**April 17, 2014**  
**BOARD OF COUNTY COMMISSIONERS**  
**ORANGE COUNTY, FLORIDA**  
**Y14-764 MM / ADDENDUM #3**  
**ORANGE COUNTY CONVENTION CENTER WEST BUILDING PHASE 1 HALL D**  
**CATWALK POWER**

**ELECTRICAL:** E1.2.00, E2.5.02, and E5.2.01(Rev 1 dated 4/8/14)

**E1.2.00**

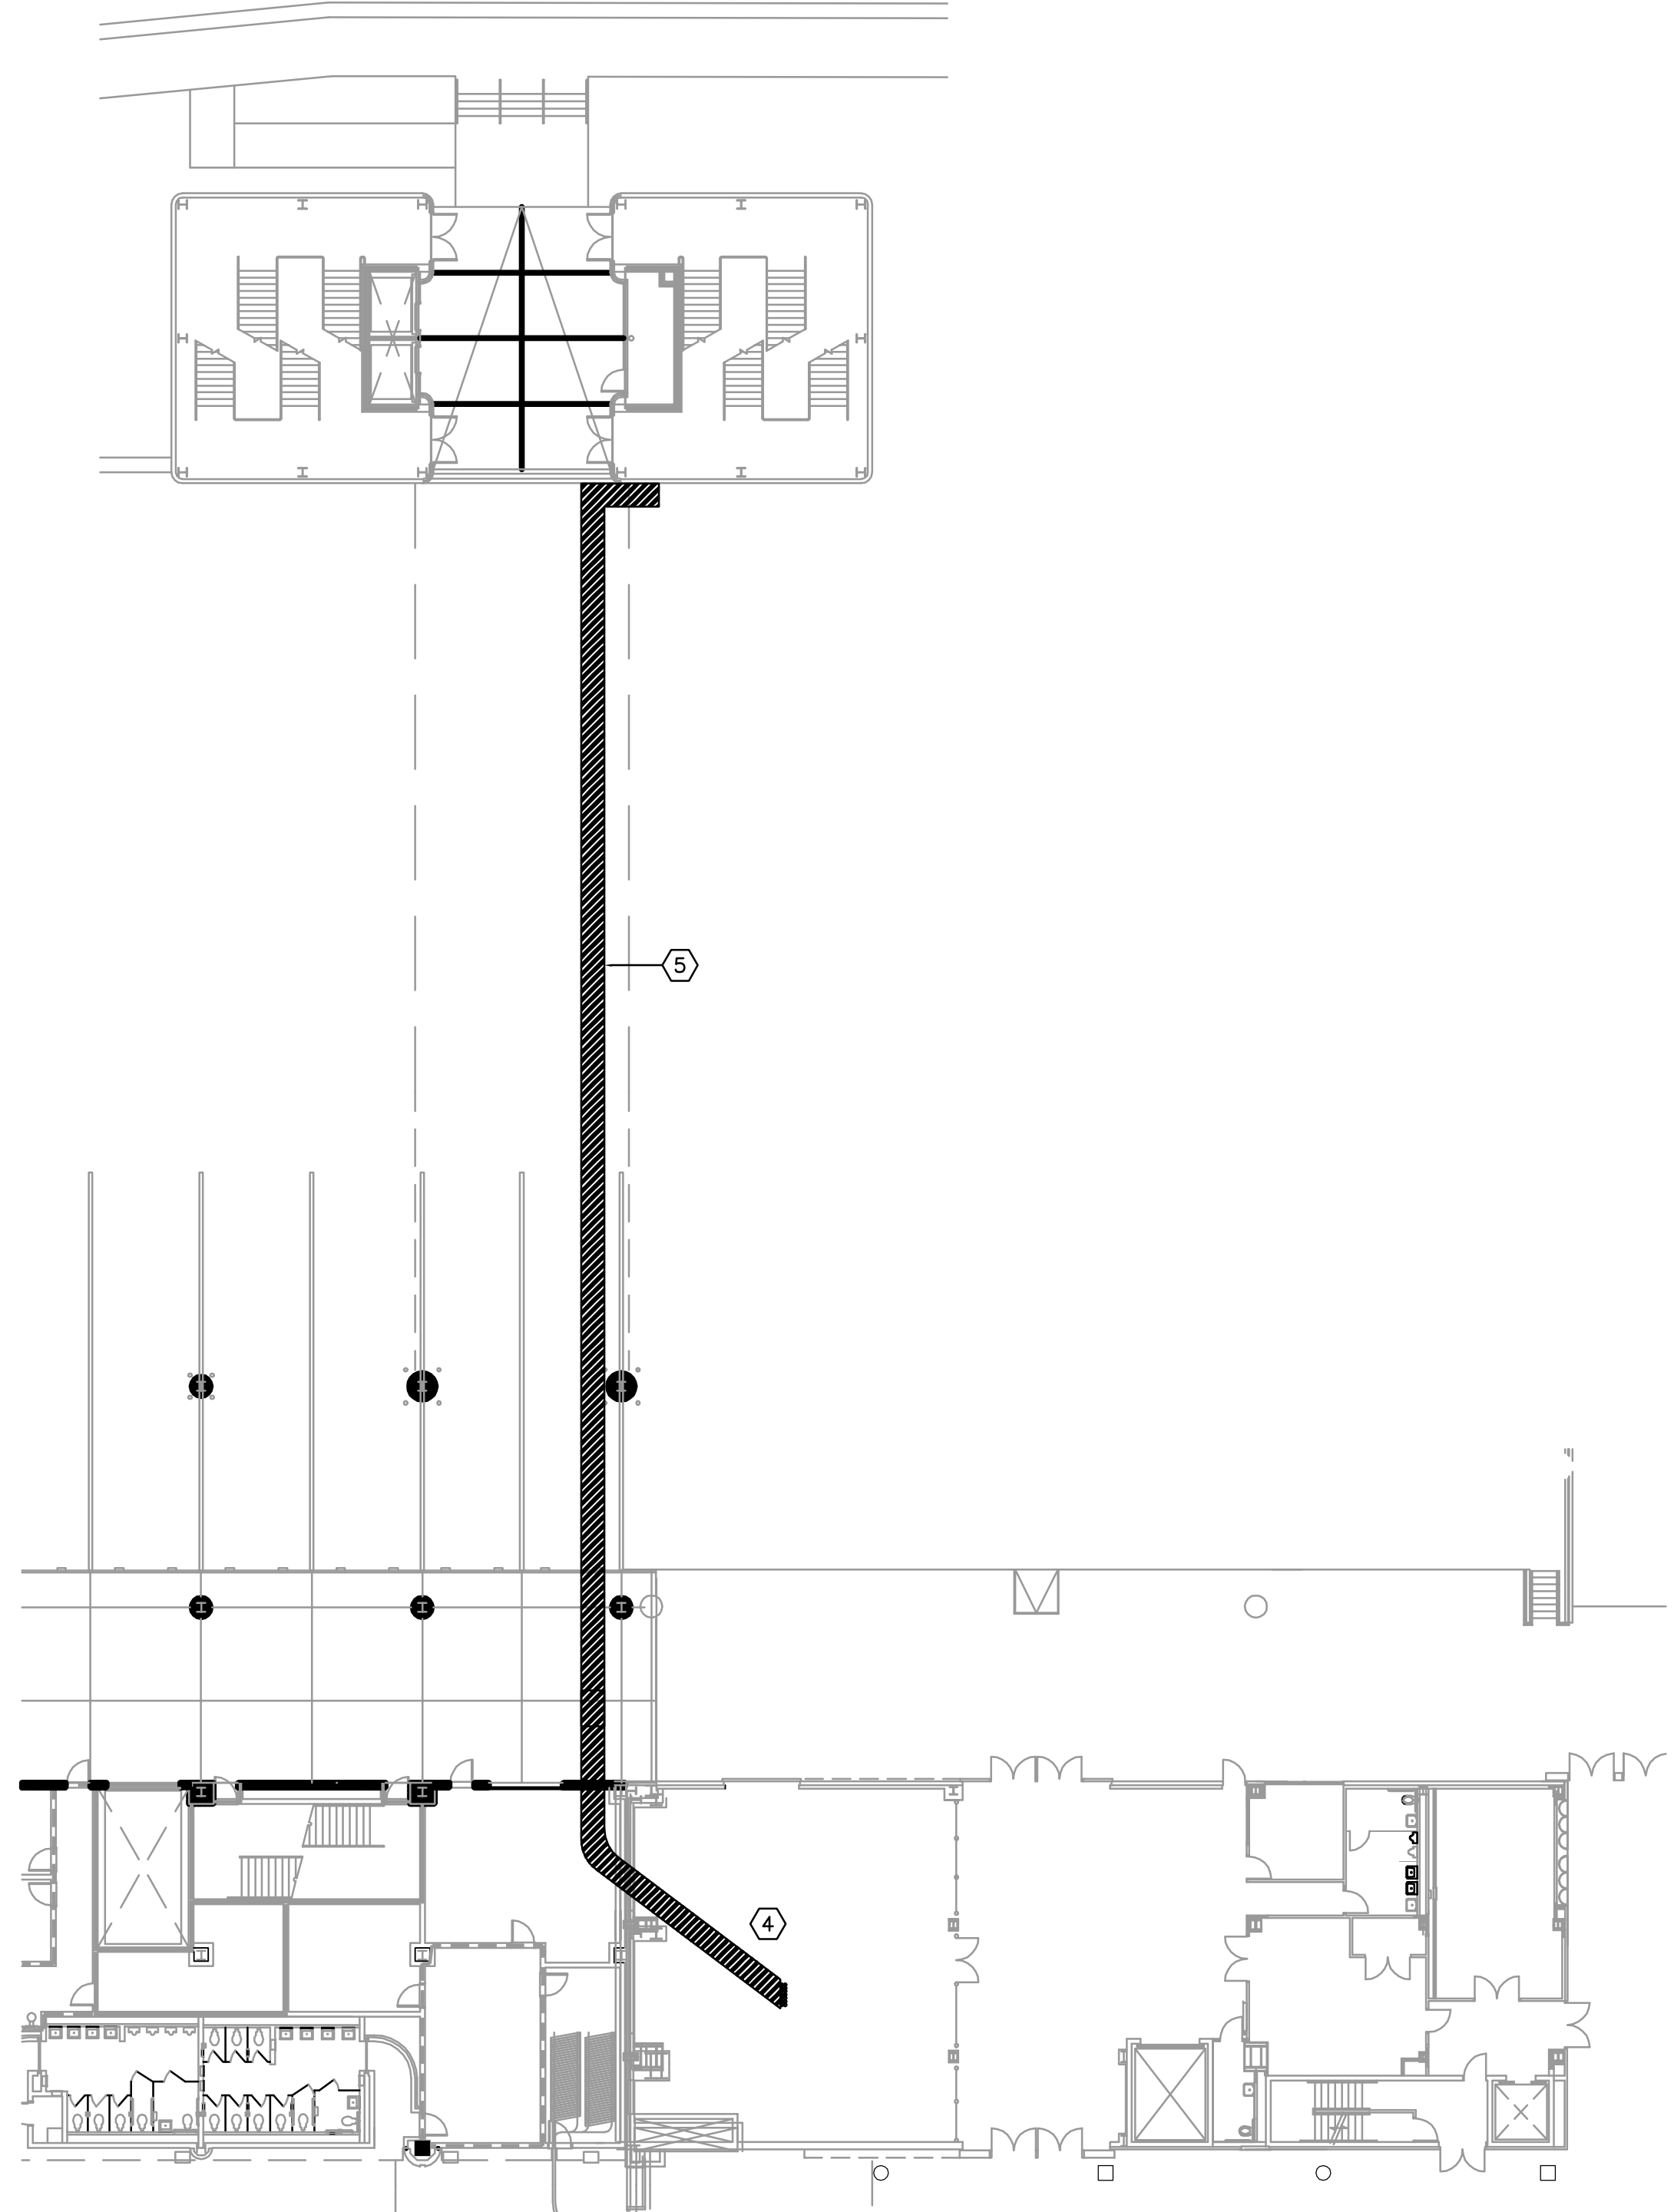
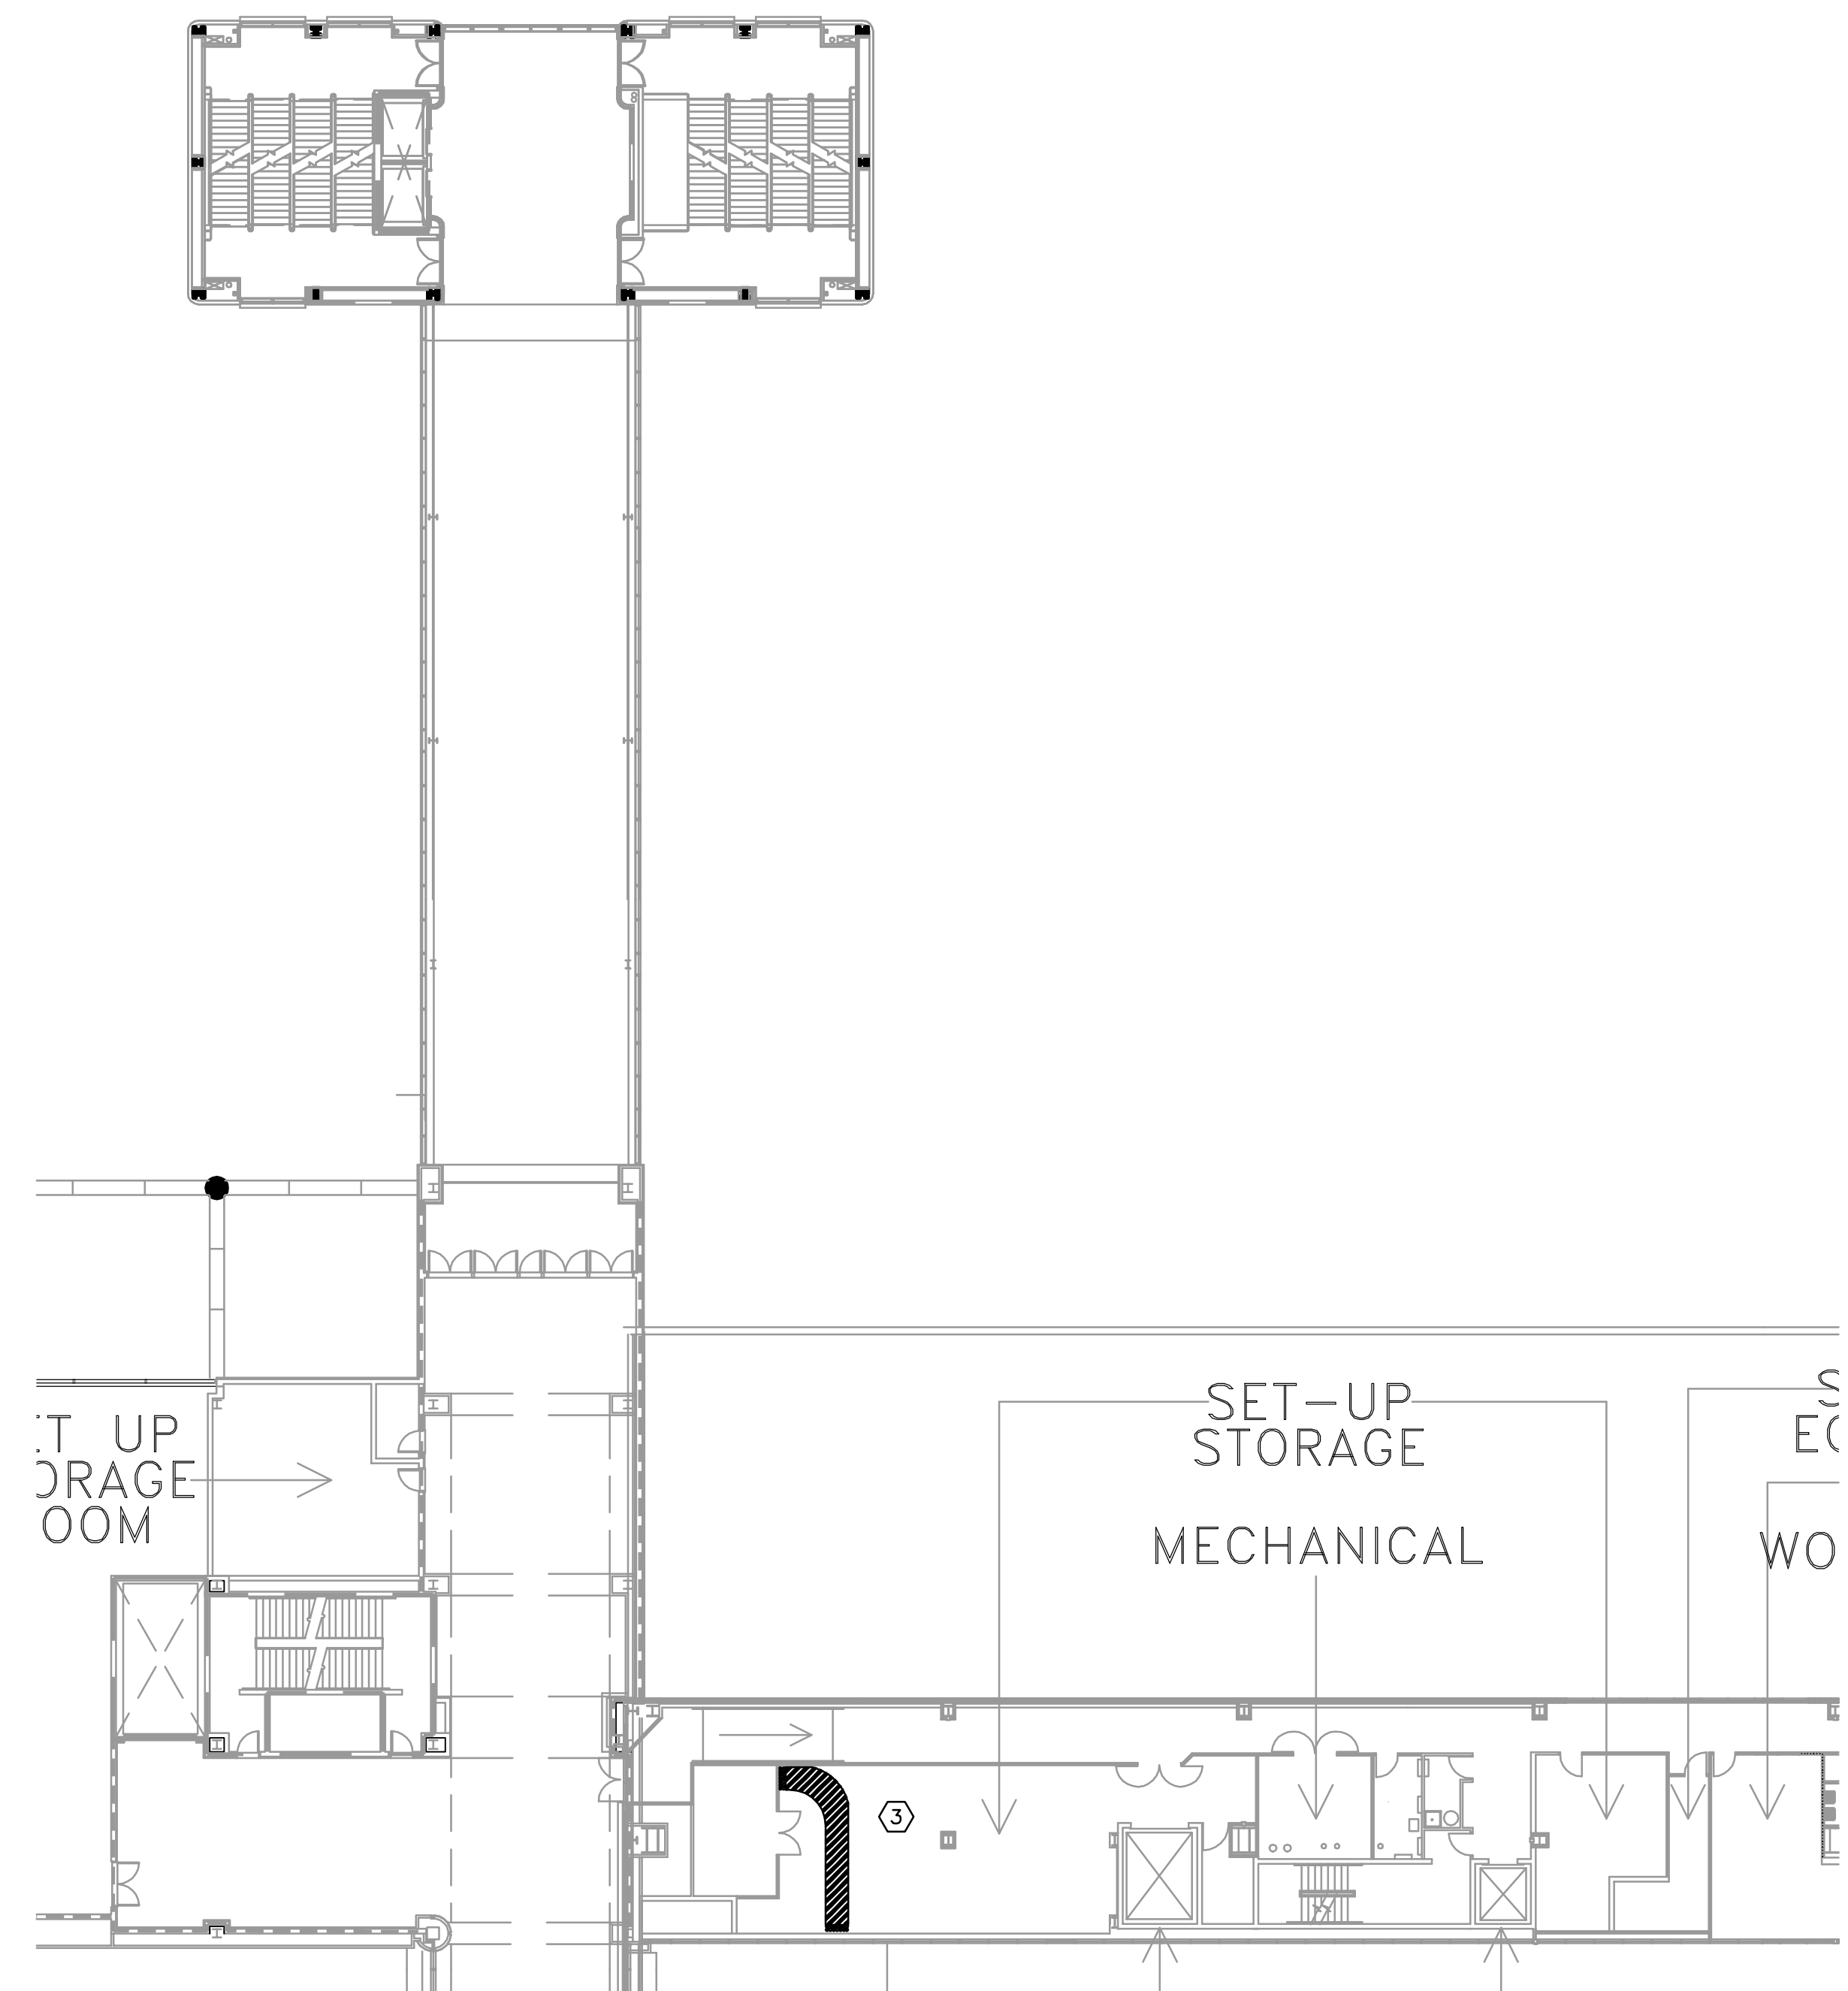
- 15 Upon further inspection the room that the hall divider doors pockets into which was shown to us on the walk thru to turn up in is under the breeze way and not a possible path. I was not able to gain access to the adjacent rooms on either level 2 or 3. There is a 4-5' cavity on the hall side of the divider storage room that has huge steel infrastructure the conduit needs to pass horizontal thru that cavity then turn up. Can someone with access to the rooms meet with us to help us determine what options are possible?

**Response:** Refer to new detail on sheet E5.2.01 for part numbers.
- 19 Please confirm the path in which the feeders are to be installed, from MSB 30 to the new gear location in the mezzanine.

- 33 Pursuant to conversations during the 2<sup>nd</sup> walkthrough, there are some challenges to bringing in the conduit with the suggested route on the plans. During the site visit, it was mentioned that a possible acceptable route would be on the underside of the loading dock ceiling to a point somewhere between trailer dock 45 and ramp #5 on the loading dock, then vertically penetrating the existing ceiling and roof above, then turning toward the exhibit hall and up the new aluca-bond wall system on the exterior and then penetrating into the exhibit hall at the catwalk height. The specifications (16111-6.D.3.a) says conduit is not to be installed on roofs without written authorization by A/E for specific conditions. Would this be an acceptable route?

Sheet E1.2.00 – New Sheet Added – Conduit Routing Plan

**Response:** Probable conduit path shall be shown on the attached new sheet E1.2.00.
- 16 There isn't a spec for the panelboards, is aluminum buss acceptable?

**Response:** Probable conduit path is shown on attached new drawing E1.200.
- 20 Please issue structural and architectural drawings for the walls and floors the 13 conduits (question # 19) are to be run through.

**Response:** Probable conduit path is shown on new attached drawing sheet E1.2.00.
- 27 The Main switchgear is not as listed on the drawing. Could not confirm if the service to this gear is sufficient.

**Response:** Refer to new conduit routing plan on attached sheet E1.2.00.
- 29 Is the framing of the new metal panels on the west elevation above the Level 2 roof sufficient to carry the 13 3.5 rmc.

**Response:** Conduit routing shall be in accordance with new sheet E1.2.00. Conduit on new roof and penetrating new curtain wall system shall not be allowed.
